Illinois Tollway Base Sheet Revisions
--

Section M	Base Sheet Drawings	
Drawing	Modification Summary	Effective: 2019-03-01
Pole Assembly (ITS)-Series 1000		
M-ITS-1000	Elevation Views Pole Mounted ITS Element Assembly Changed disconnect switch to unfused.	
M-ITS-1003	ITS Concrete Service Pad (2 sheets) New drawing with three types of service pads for ITS poles for flat and slope installation.	
M-ITS-1004	Cabinet Wiring Diagram - ITS Pole Mounted Enclosure (Solar Powered MVDS) (2 sheets) New cabinet layout separating ITS enclosure and dedicated co-located solar generator/battery cabinet with four 6 V batteries.	
Dynamic Message Sign (ITS)-Series 1100		
M-ITS-1108	DMS Cabinet Wiring Diagram Changed to Cisco 4000 series switch. Changed IP Relay to DIN IV.	
Cabinet Wiring (ITS)-Series 1200		
M-ITS-1200 to M-ITS-1217	Cabinet Wiring Diagrams 18 new ITS enclosure drawings replace old 56 ITS enclosure drawings for clarification. Drawings 1200 to 1217 have been redone completely. Consolidated equipment configurations. Standardized to-scale equipment layout. Changed to Cisco 4000 series switch. Eliminated 24 VAC transformer and 24 VAC CCTVs. Additional 24 VDC power supply. Cat6 Ethernet sur

CONDUIT DETAILS AT
INTEGRAL ABUTMENT BRIDGE
STANDARD SLOPE WALL

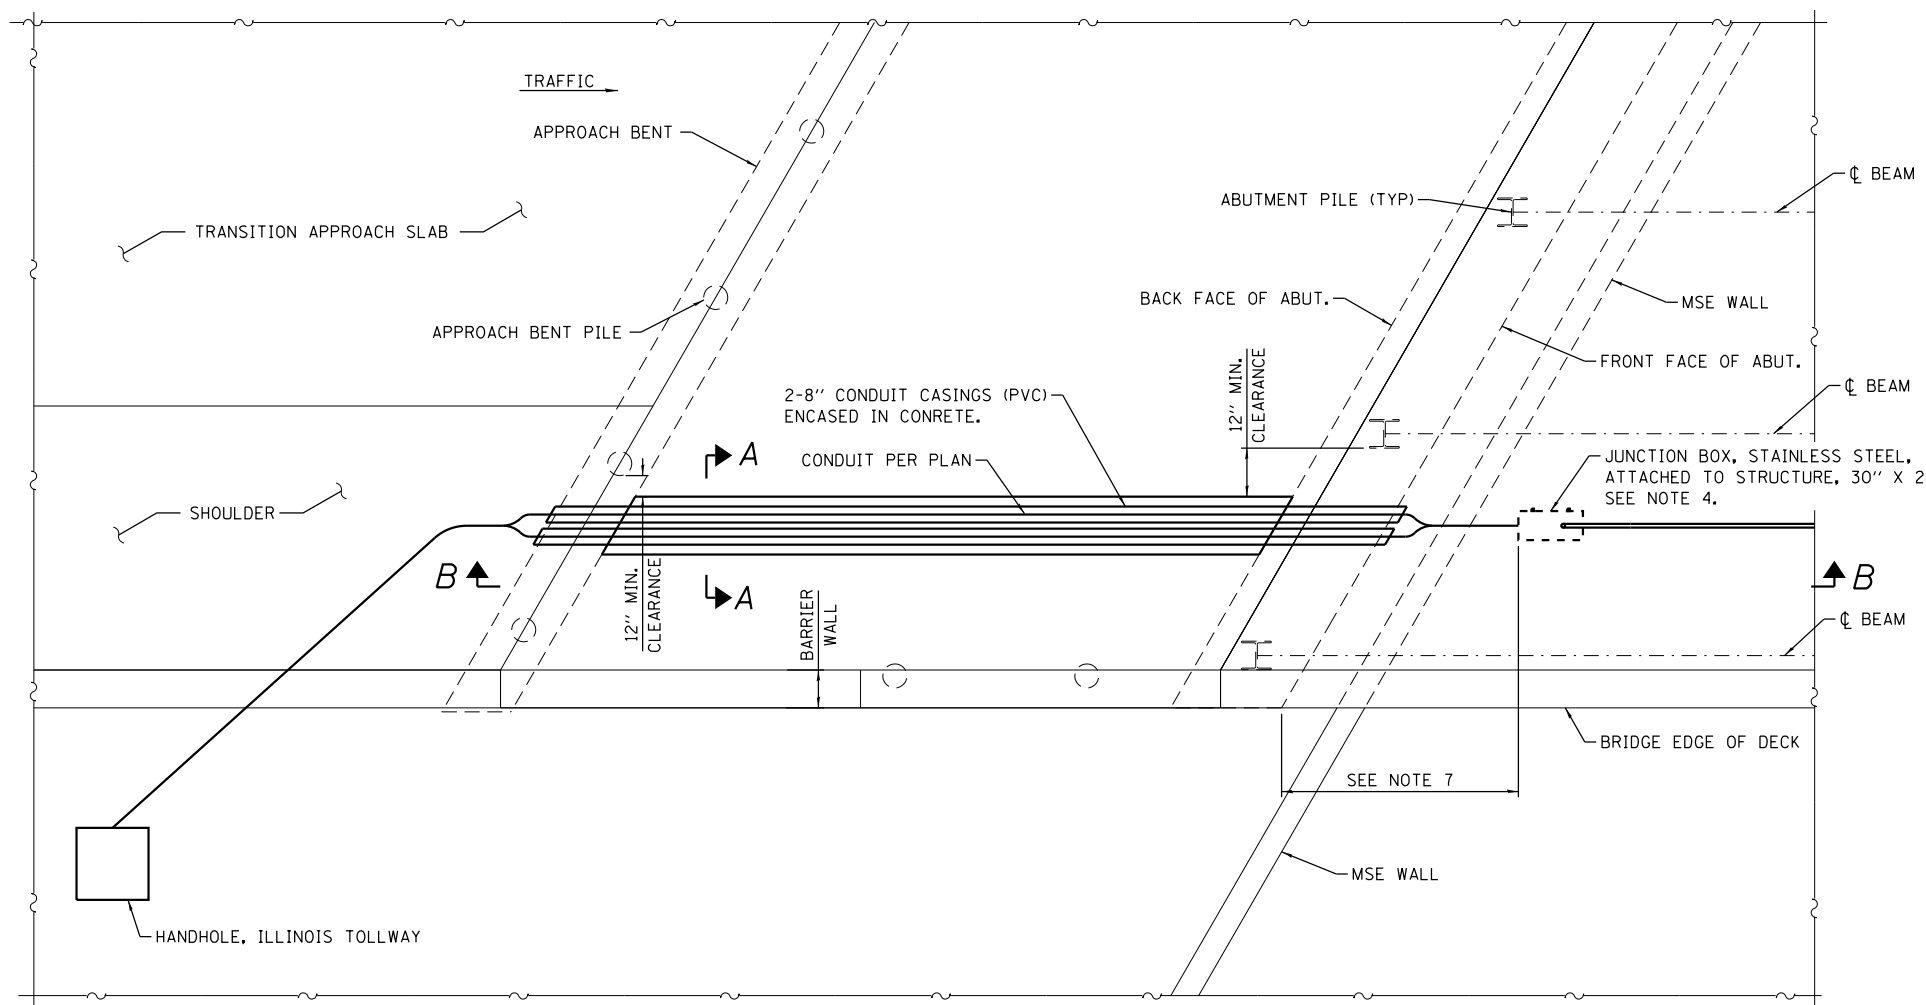
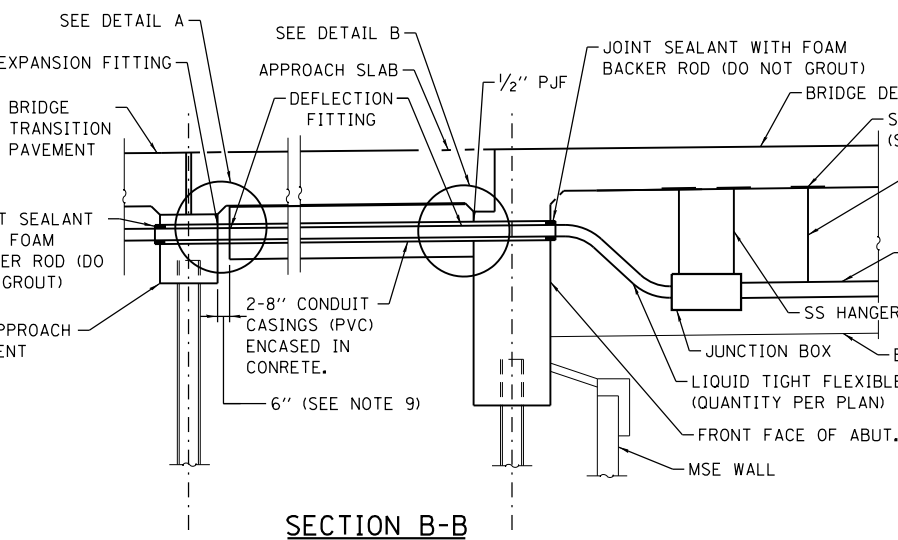
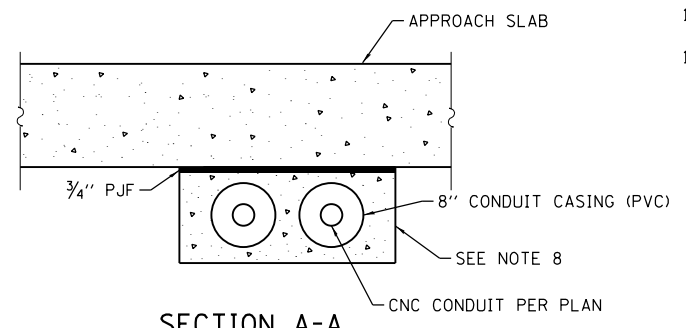
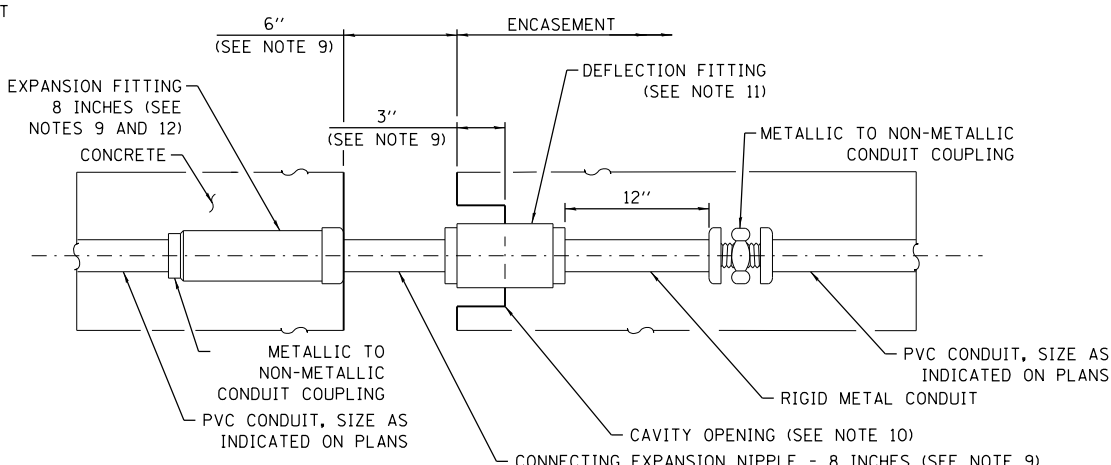
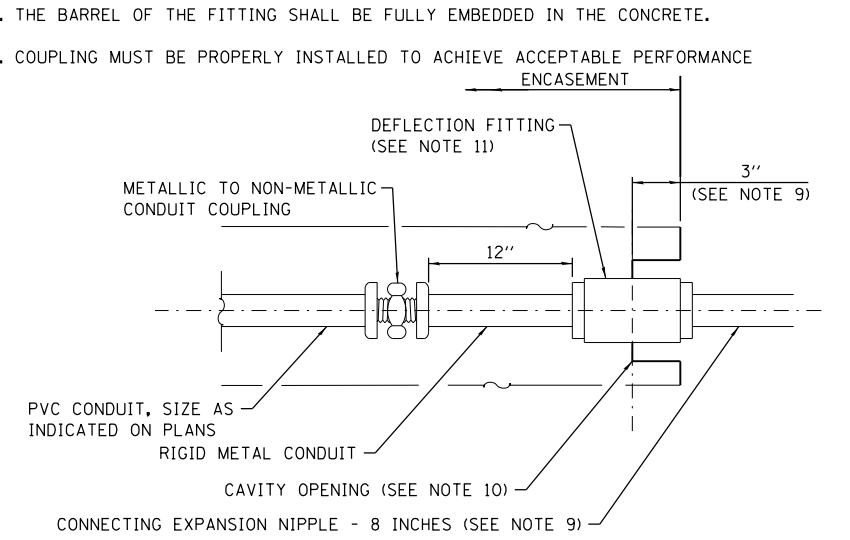
M-ITS-1503	Cabinet Wiring Diagram - Tower Mounted CCTV Revised to show 24 VDC power supply, drawing drawn to scale.	
Flashing Beacon (ITS)-Series 1700		
M-ITS-1701	Flashing Sign Beacon Installation Wiring Diagram Revised to show full cabinet layout accomodating flasher beacon. Re-drawn to scale. Added flashing beacon, new surge suppressor.	
IPDC Facility (ITS)-Series 1800		
M-ITS-1802, 1803, 1805, 1806, 1809, 1810	IPDC Facility Building modified to accommodate larger generator room door, door stoppers. Additional exterior CCTV cameras. Added bird deterrant. Added exterior GFCI outlets.	
M-ITS-1802	Note 2: Seal door opening and protrusion/access against rodent and bugs. Note 3: Install removable stainless bollards per Illinois Tollway Maintenance.	
M-ITS-1803	Added 240 V service power outlet outside side wall.	
Conduit Details at Integral Abutment Bridge (ITS)-Series 1900		
M-ITS-1900	Conduit Details at Integral Abutment Bridge with MSE Wall (Sheet 3) Removed note stating concrete encasement to be placed monolithic with the approach slab. Added 0.5" PJF at the back of the abutment and approach bent. Added 0.75" PJF between the approach slab and encasement. Added detail for deflection and expansion fittings at the encasement and pile bent. Added detail for deflection fitting at encasement and abutment.
